**Vintage Road, Underdale – change to road closure**

The Bicycle Institute of SA has been representing the interests of commuter and utility cyclists for forty years. We would like to submit the following comments on the proposed changes to the road closure at Vintage Road, Underdale, to improve the design concept for cyclists.

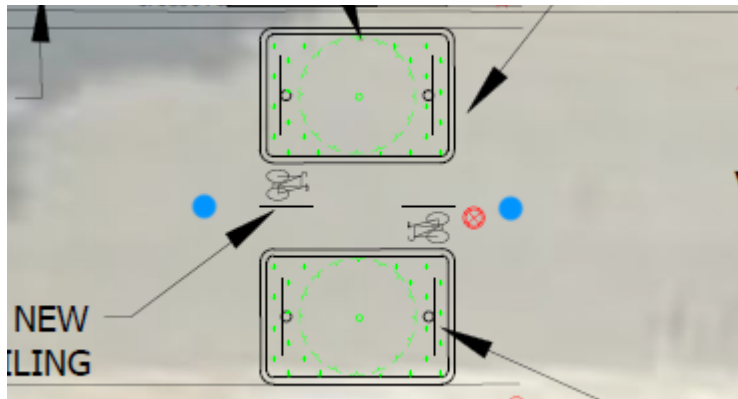
1. While the new bicycle access is appreciated, no dimensions or scale are shown on the concept plan made available on your website. However, the through bicycle access appears to be about 2.0m wide, i.e. 1.0m in each direction. This is narrow for bicycle access. The Austroads *Guide to Road Design Part 6A: Pedestrian and Cyclist Paths* (GRD6A) would specify a minimum width for a two-way path of 2.5m. (In this use, the bicycle access is functionally a path). We further recommend that the kerb through the bicycle access be chamfered or laid back rather than upright as shown in the artist's impression, as the potential to hit pedals on upright kerb leads cyclists to track more centrally where this kerb type is provided, and this is not desirable in this location.

2. While commonly used, the rails indicated on the concept plan and shown in the artist's impression are not consistent with good practice, specifically section 10 of GRD6A (being the section that deals with terminal devices). In fact, these are also not consistent with the previous *Austroads' Guide to Traffic Engineering Practice Part 14: bicycles* in either the original 1996 version or second edition published in 1999, and the Bicycle Institute would like to see these hazardous devices removed wherever possible.

GRD6A recommends waiting for issues with vehicular access of bicycle paths such as these to arise before installing terminal devices aimed at preventing these, on the basis that such issues may not occur.

However, understanding that Council may wish to be proactive or at least have a design solution should such issues arise, we would advise installing a complying bollard (minimum width 100mm, treated with retro-reflective tape and highlighted with line-marking) at a point desirably 1.2m (minimum 1.0m) in front of the bicycle access. This prevents vehicular access but does not create the same type of squeeze point as a rail does. The figure provided overleaf illustrates this concept (in blue, being a colour not otherwise used in your concept design).

3. 'Bicycle excepted' signage (R9-3B) should be provided beneath the R2-14B(L) and R2-6B(R) signs to allow cyclists to have greater permeability through the local street network (and noting that cyclists can and will use the right turn lane in Holbrooks Road to store safely when crossing this road.)

4. Given the few vehicles that will be using the western section of Vintage Road, and given that this appears to be as much as 9.0m wide, we query whether this could not be designed at a narrower width at Holbrooks Road to allow the significant gum tree on the southern side to be retained – perhaps with pruning of lower limbs – and to moderate entering vehicle speeds. We note that other streets in Adelaide have road widths narrower than 8.0m, yet still support access by relevant vehicle types. A narrower throat to Vintage Road would also discourage vehicles from parking too close to Holbrooks Road. Drainage may well be an issue, however given that the indicated culverts exist currently, it does not appear vital that the street be made quite so wide at Holbrooks Road.
